Laila Styles Ltd.

Bahadurpur, Gazipur.
(24.077527, 90.369504)
27th January 2019 & 04th February 2019

Observations

Floor loading plan

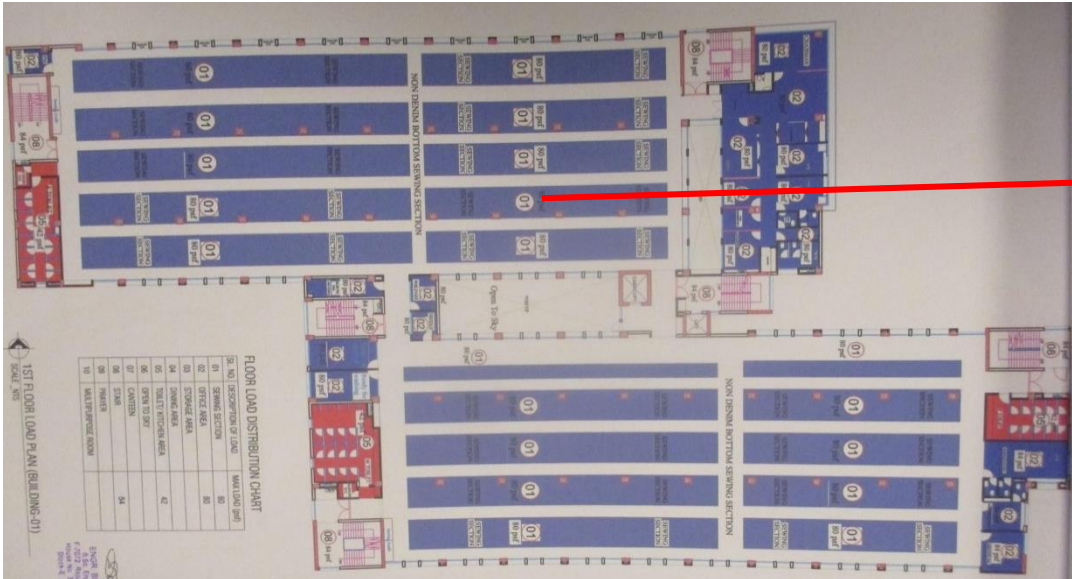
Load plan is required to be reviewed

We have checked the column capacity based on minimum concrete strength and found that the column stresses exceed above normal design limit considering the provided load plan. But considering 3 Kpa live load and minimum concrete strength, the column stresses are within normal design limit. The provided load plan was based on 4000 psi concrete strength of column. Insufficient number of cylinder test result from column were provided. Strength of two of the cylinder test result for column were found to be 4102 psi and 4303 psi which were not adequate for evaluation of the design concrete strength of column. Factory engineer is required to review the provided load plan.

Item No.	Observation	Recommended Action Plan	Recommended Timeline
1	Load plan required to be reviewed (Building-1 Production Building)	Maintain 3 Kpa load on all floors.	6-weeks
2	Load plan required to be reviewed (Building-1 Production Building)	Produce and actively manage a loading plan for all floor plates within the factory giving consideration to floor capacity and column capacity if loading above 3kpa is considered.	6-weeks
3	Load plan required to be reviewed (Building-1 Production Building)	Continue to implement load plan.	6-months
4	Discrepancy in as-built drawing (Building-1 Production Building)	Building Engineer to prepare accurate as-built structural drawing.	6-weeks
5	Columns susceptible to vehicle impact (Building-2 Warehouse Building)	Install safety guard to protect the columns from vehicular impact.	6-weeks
6	Implement the provided load plan (Building-2 Warehouse Building)	Maintain the load plan and ensure that the workers understand the loading requirements	6-weeks

First floor working architectural plan

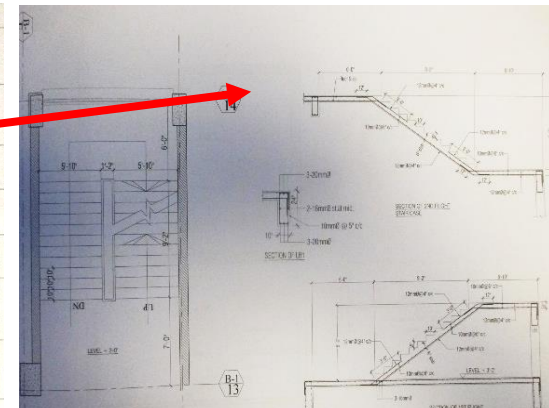
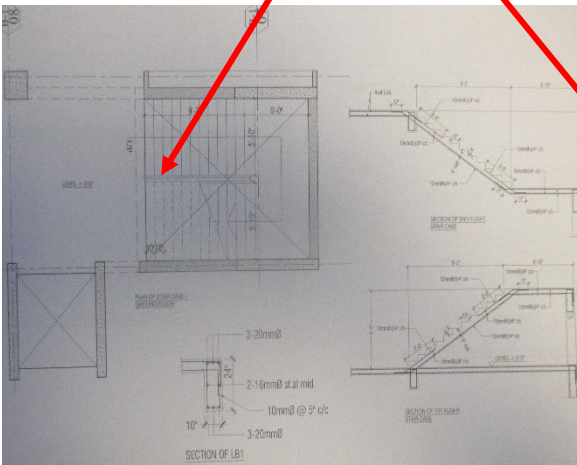
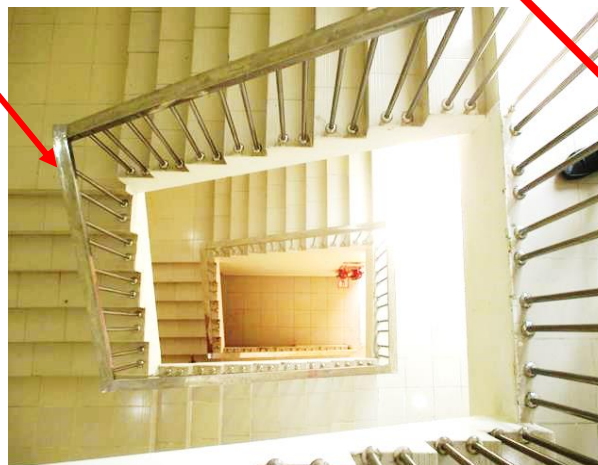
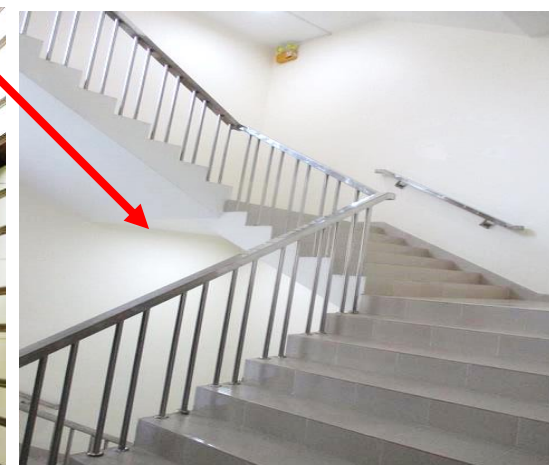
For Stair case-1 and Stair case-4, as-built drawing do not match with as constructed condition. In as built drawing for staircase 1 shows two flights where as-constructed structure has three flights.

2nd to 4th floor Beam layout plan

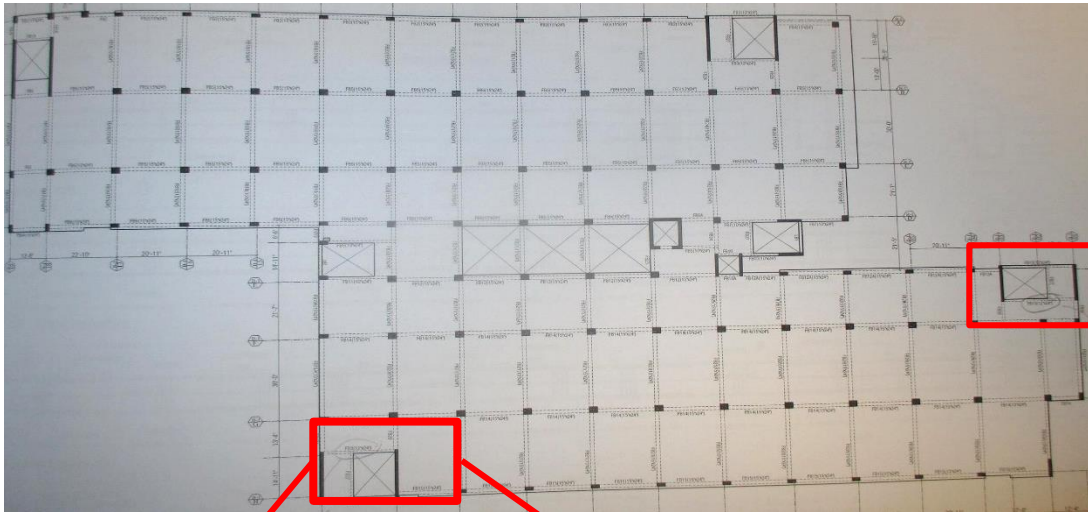
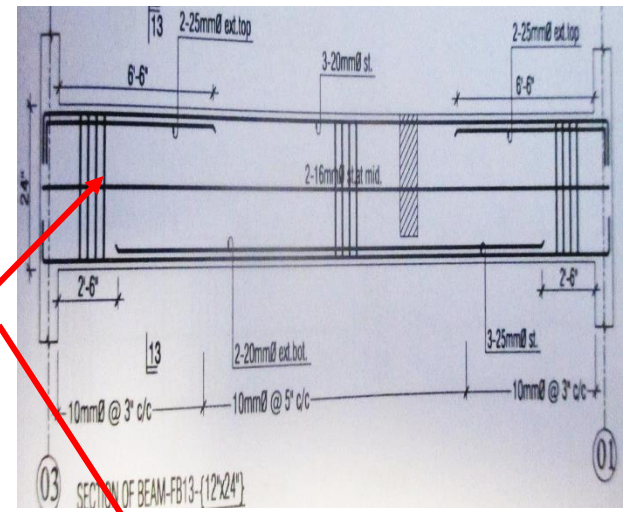
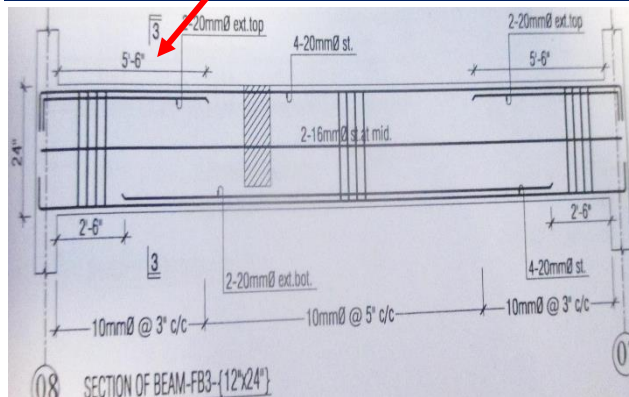
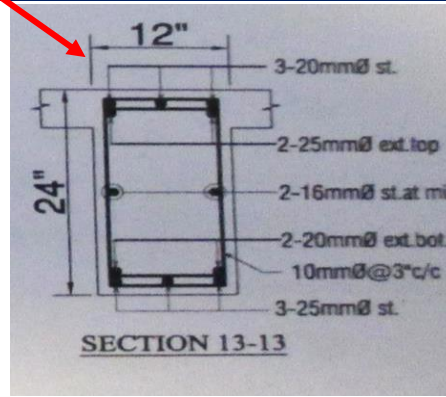
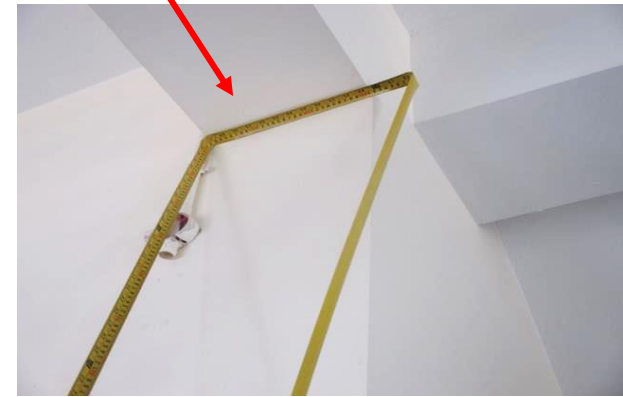
Floor beam dimension for FB-3 & FB-13 did not match with as constructed condition. In as built drawing, FB-3 & FB-13 are shown 12"x24" but as constructed size is 10"x24".

2nd Floor Load Plan

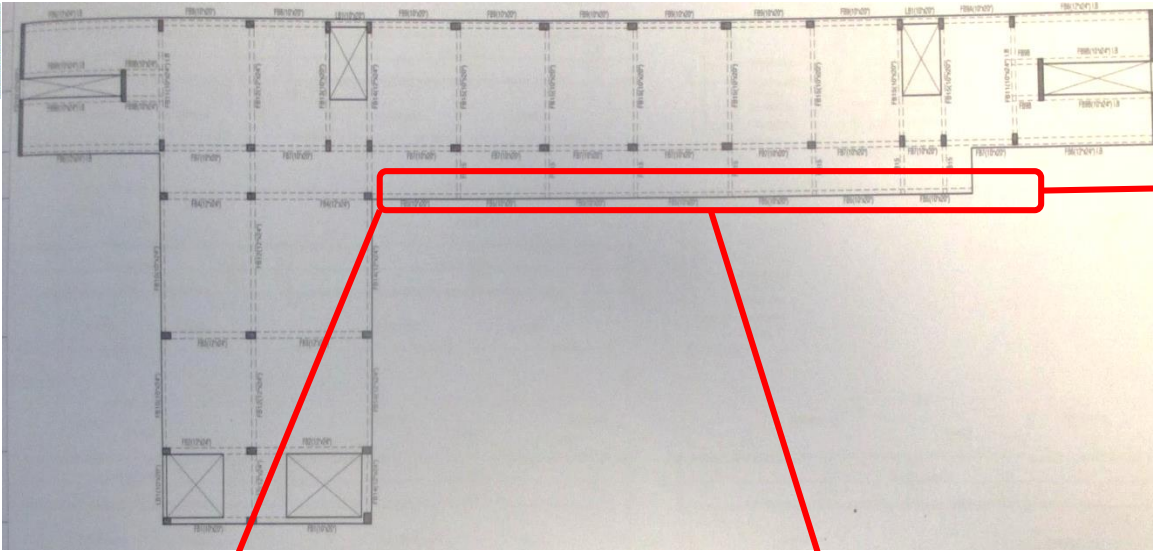
Implement load plan

Maintain the load plan and ensure that the workers understand the loading requirements. The load plans are required to be posted on each floor level.

First floor roof beam layout plan

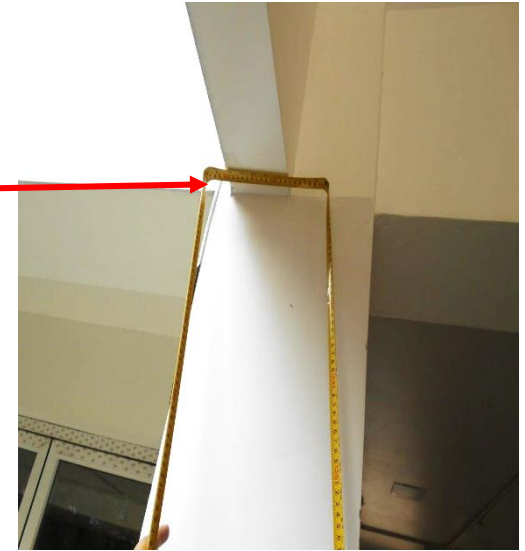
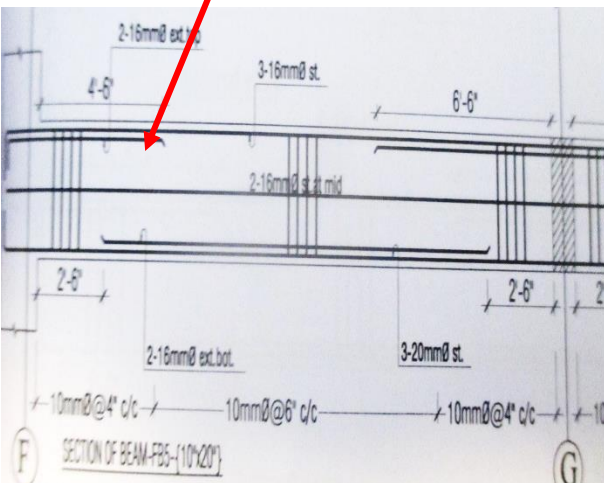
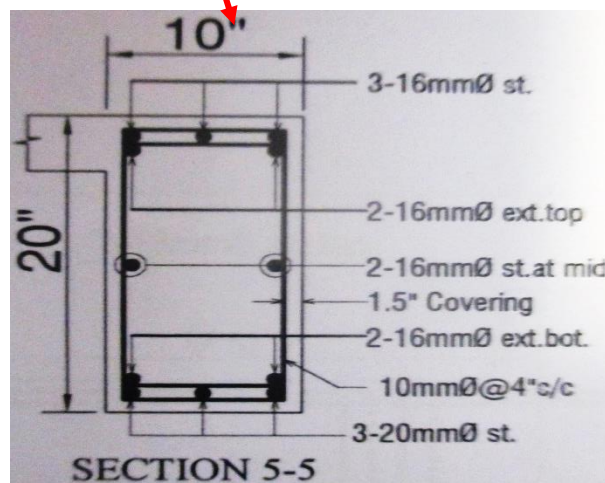
First floor and roof level beam, FB5 measured to 5" x20" whereas it is shown 10" x20" in as built drawing.

7	Discrepancy in as-built drawing (Building-4 HR Building)	Building Engineer to prepare accurate as-built structural drawing.

Column layout plan

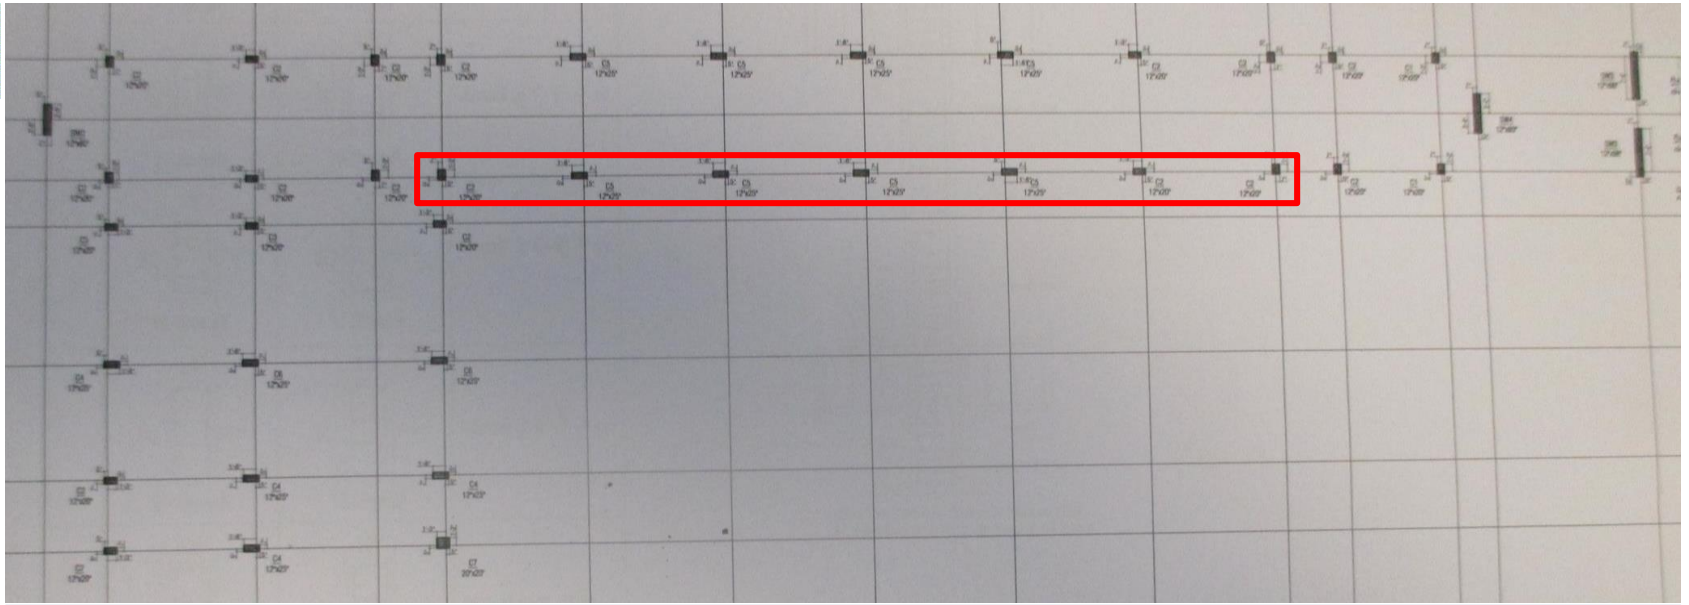
Grid spacing at highlighted location do not match with on site condition.
